NRA presentation

C-1 Regulatory process

2nd IAEA Regulatory Review Mission on ALPS Treated Water Handling
17 January 2023

Tritium concentration distribution in the tank after the demonstration test

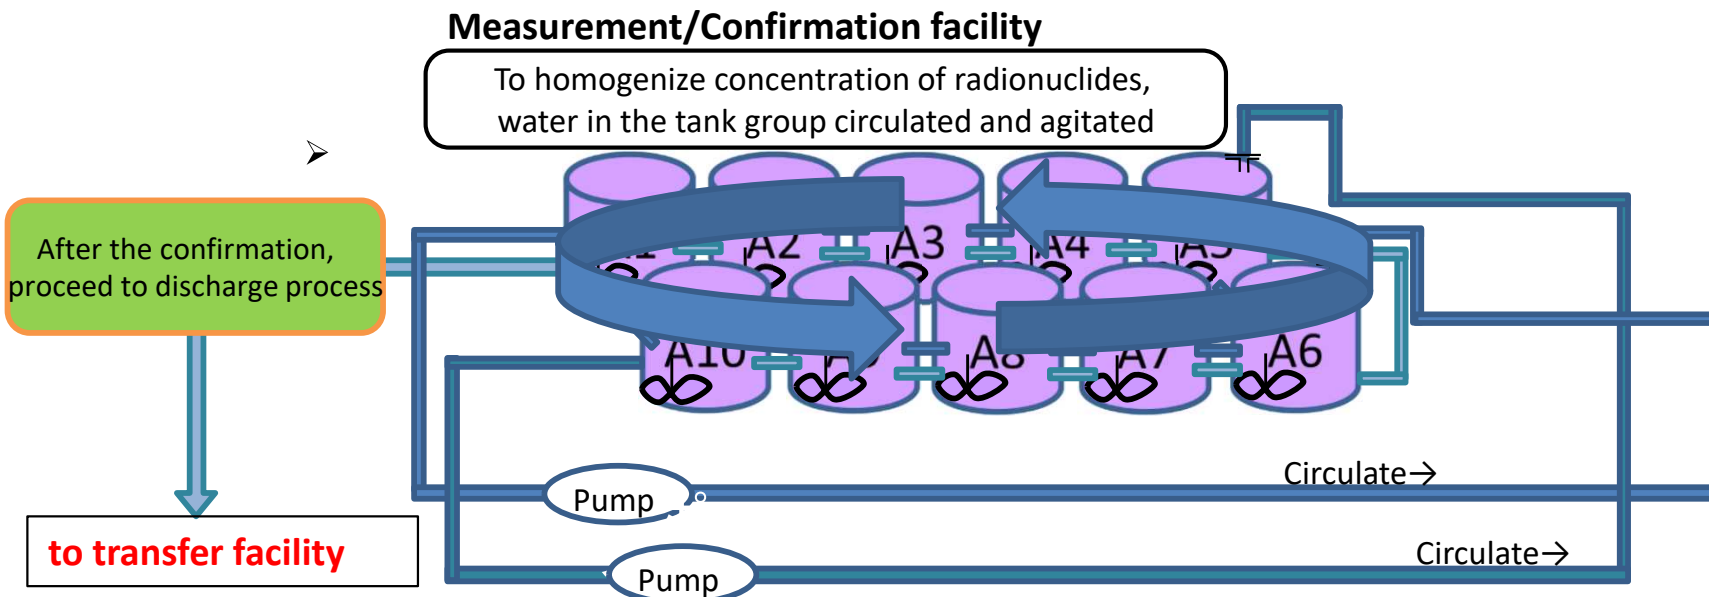
【NRA examination result】

- Homogeneity of the concentrations of radionuclides is achieved by the circulation and agitation of ALPS treated water in the tank group for a sufficient time.
- A step to the discharge process is taken after the determination of tritium concentration required for setting the flow rate of ALPS treated water and the confirmation that the sum of the ratios of the other radionuclides to each concentration limit in the Notification is less than 1.
